File In Section: Product Recalls
Bulletin No.: 10091A
Date: April 2010

PRODUCT SAFETY RECALL

SUBJECT: Voltage Regulator Internal Low Resistance Short

MODELS: 2010 Chevrolet Express
2010 GMC Savana
2500/3500/4500 Series Equipped with 145 Amp Generator (RPO KG3/KD9)

2426929

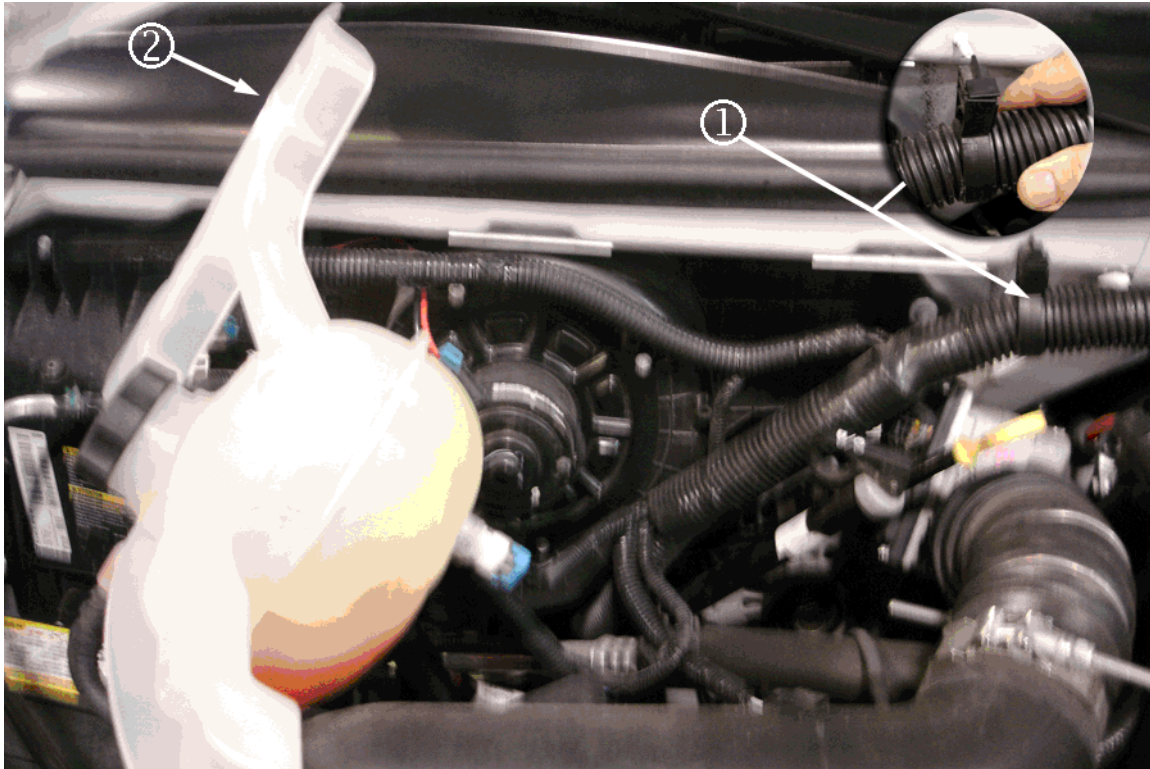
Generator Build Date Location is at the 11 o'clock position on gasoline engines and at the 2 o'clock position for diesel engines. (1) Gasoline Engine Generator Build Date Location shown.

1. Determine build date of the generator. Refer to the illustration for build date location.

- If the generator build date is January 12, 2010 or later, remove the generator and replace it with a new one. Proceed to step 2.
- If the generator build date is BEFORE January 12, 2010, replacement of the generator is NOT required. No further action is required.

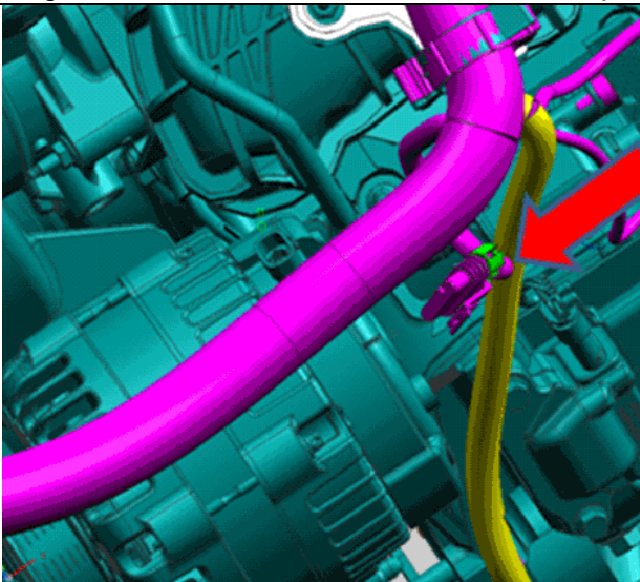
A. Disconnect wire harness (1) from the stud as shown in illustration.

B. Remove coolant surge tank fastener (2) and set coolant surge tank to the passenger side of engine compartment as shown in illustration.

C. Clean generator in the 2 o'clock area with a shop towel.

D. Use a pencil to shade the generator build date code.

2426932

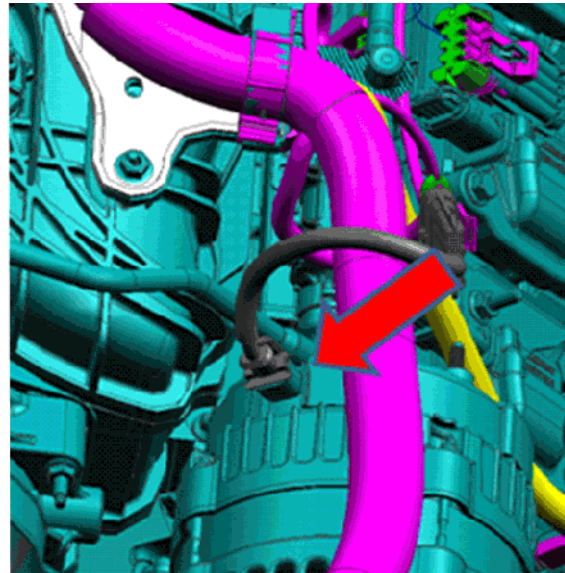
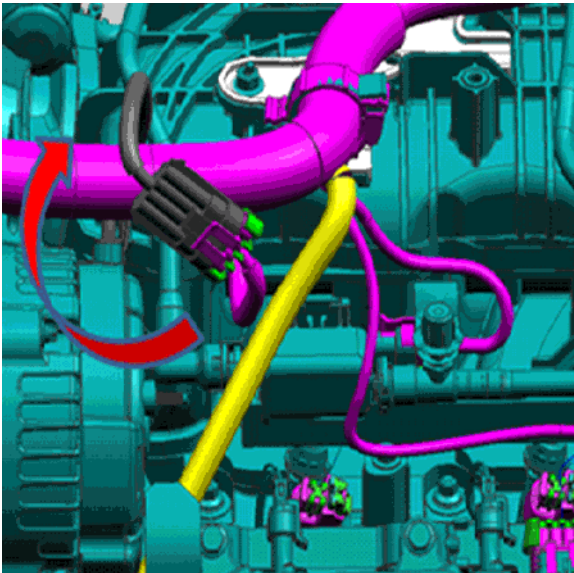
4. Route engine harness generator inline below the main branch of engine harness.
